MARK UP OF SERVICE ROUTES - GAS/ELECTRICITY/FOUL/STORM/WATER - REV 1

MAY 2017

EXISTING SERVICES DWG.

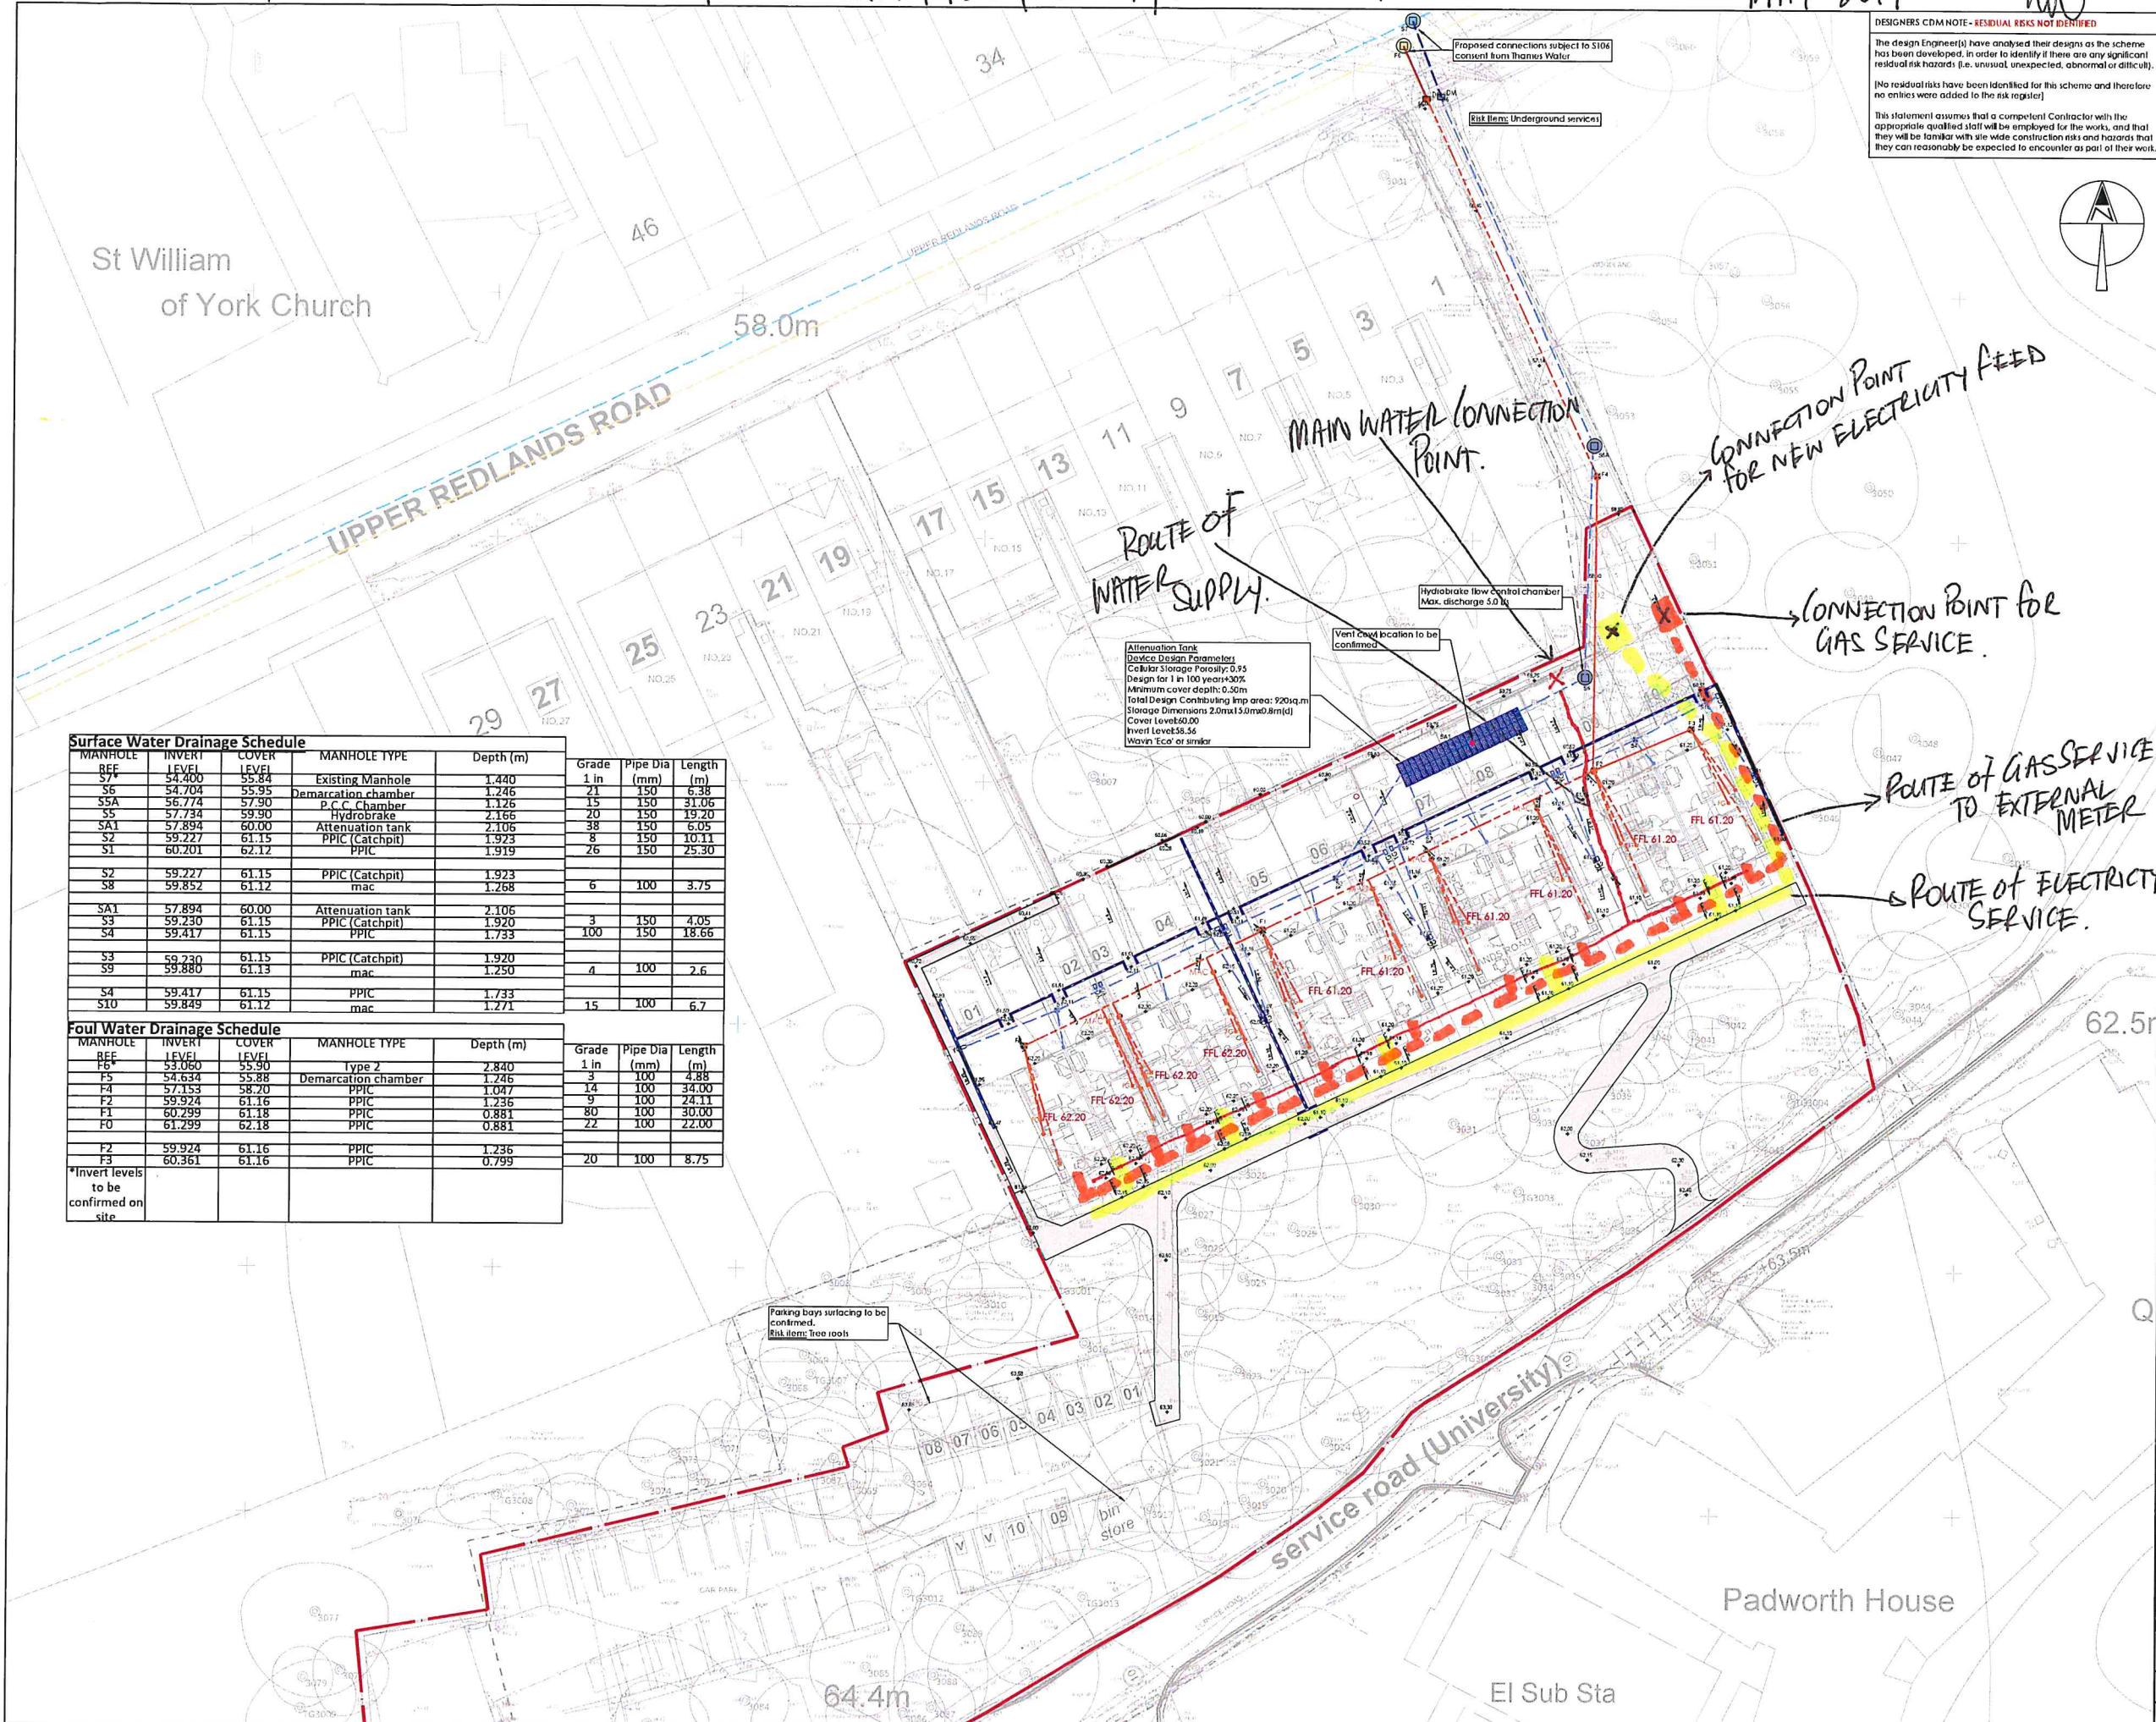
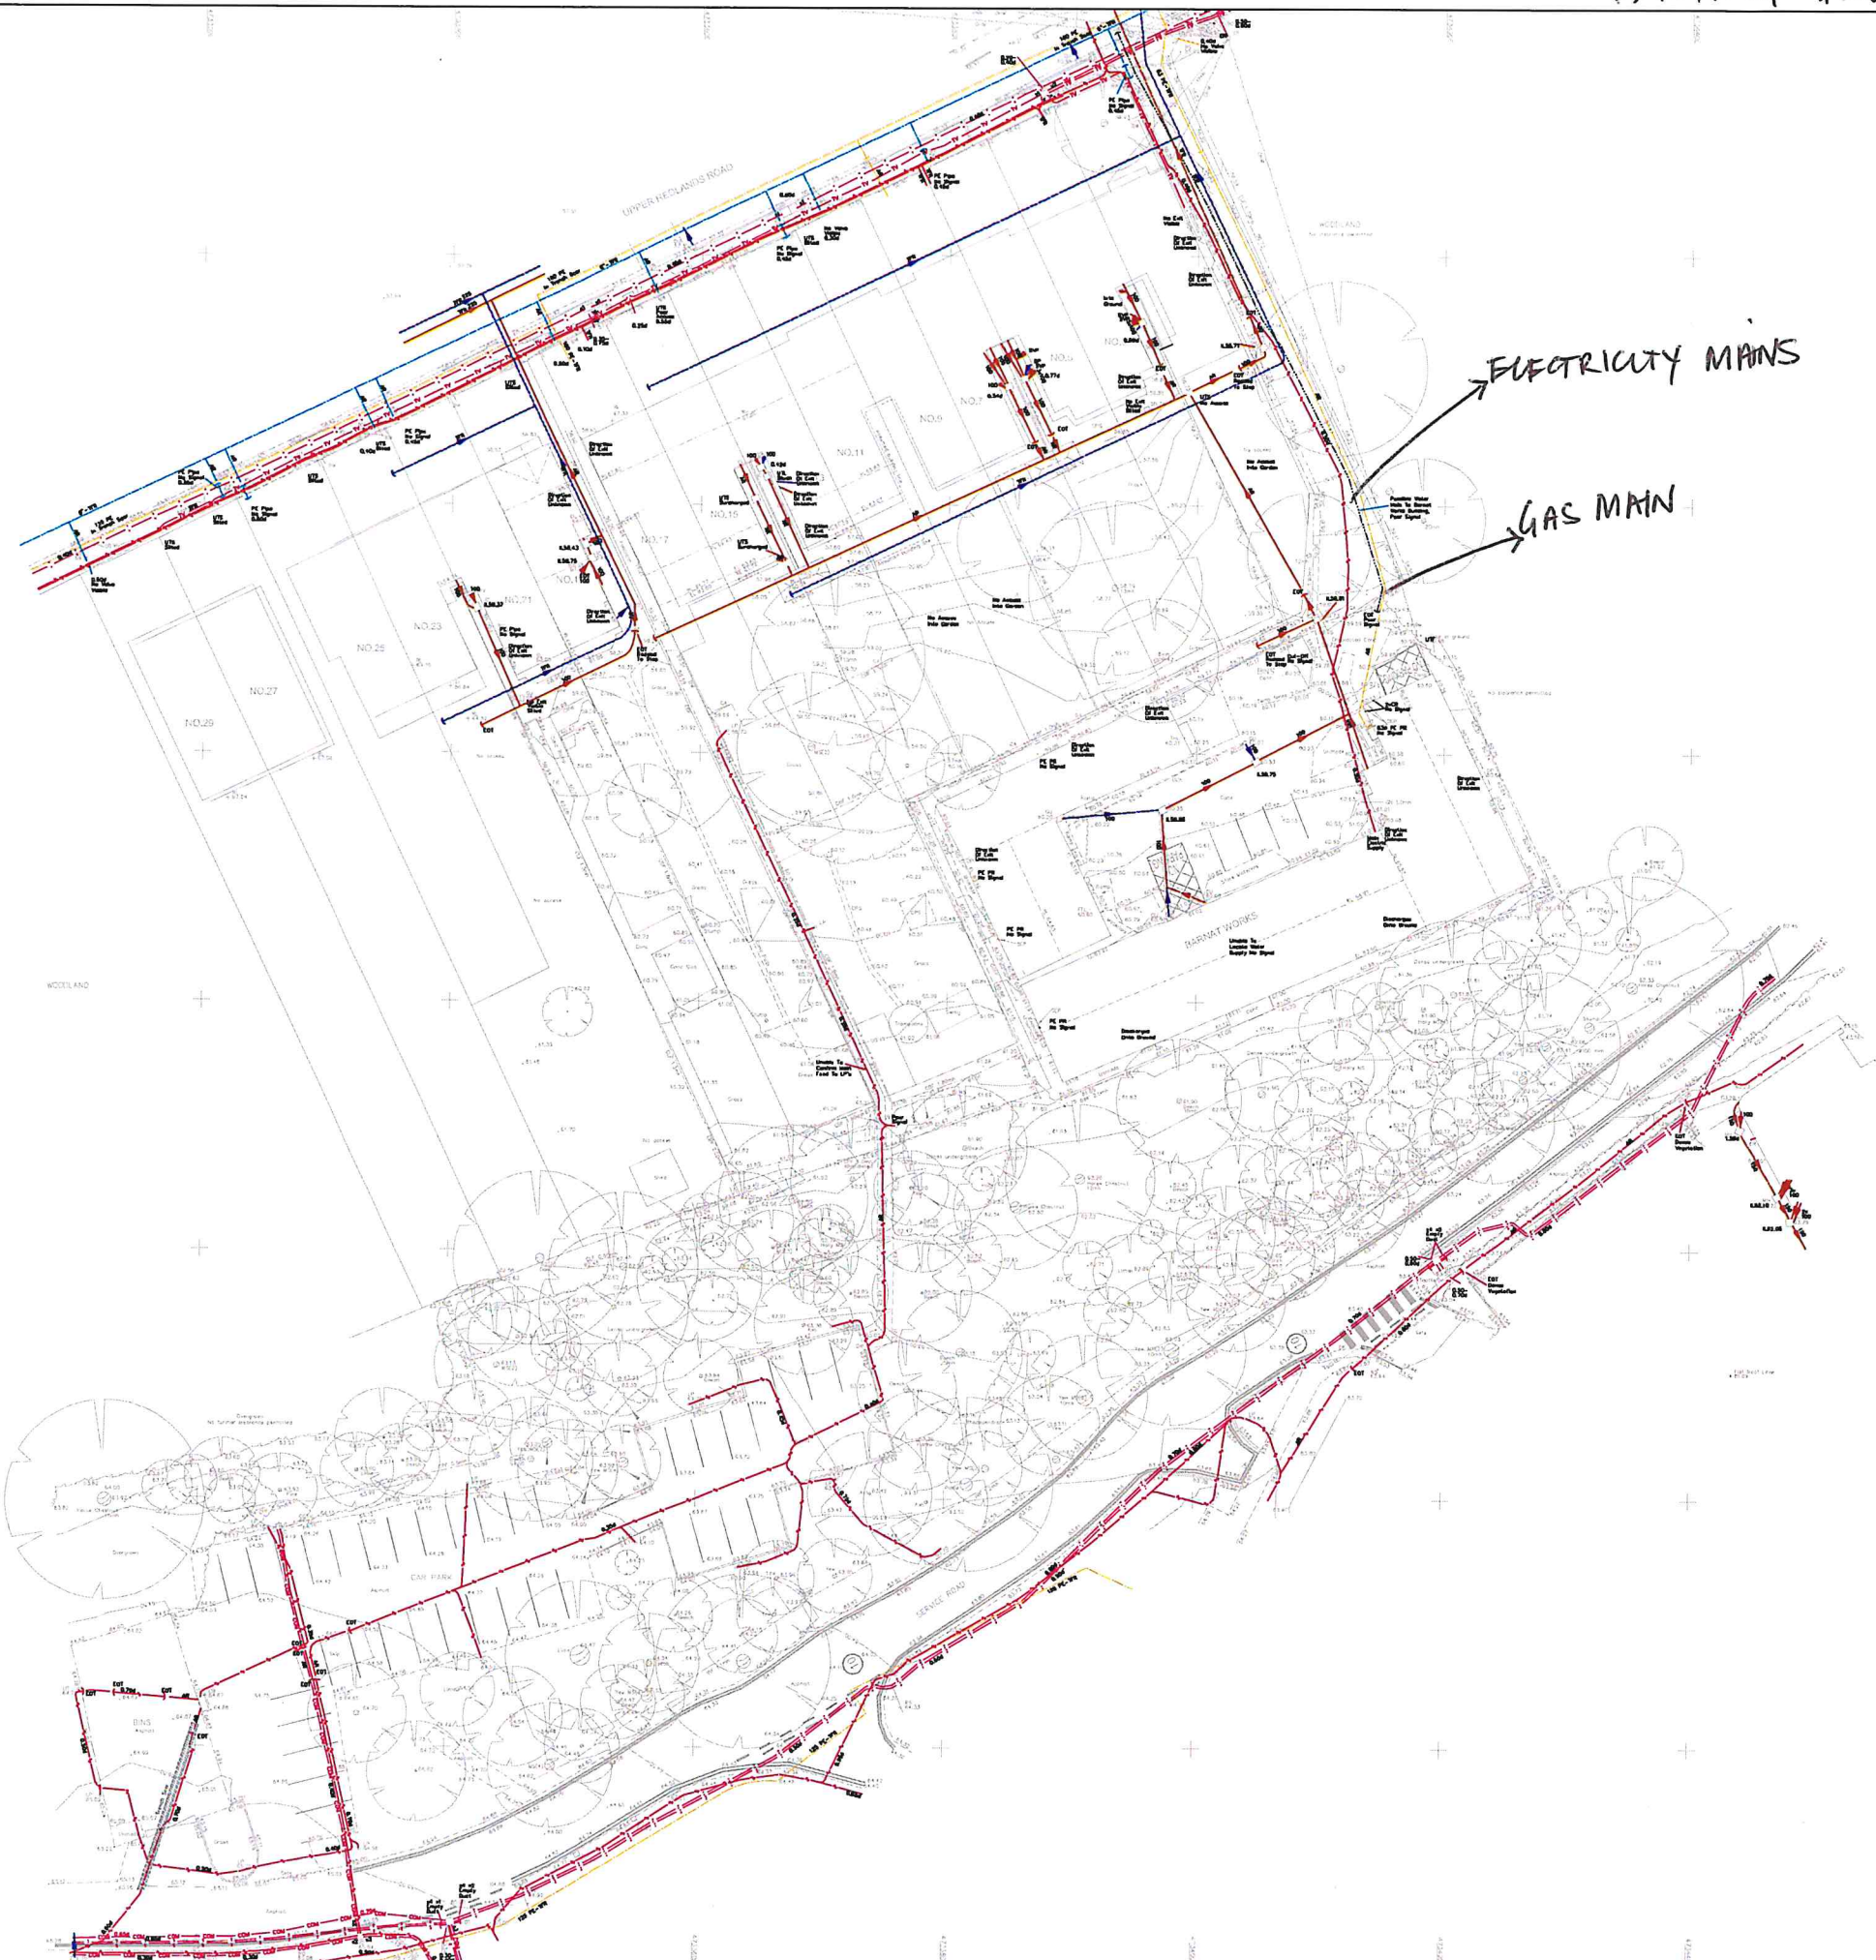
NOTE: SERVICES PROVIDER TO KEEP A MAX OF 2M AWAY FROM BUILDINGS TO ENSURE TREE PROTECTION ZONE IS MISSED.
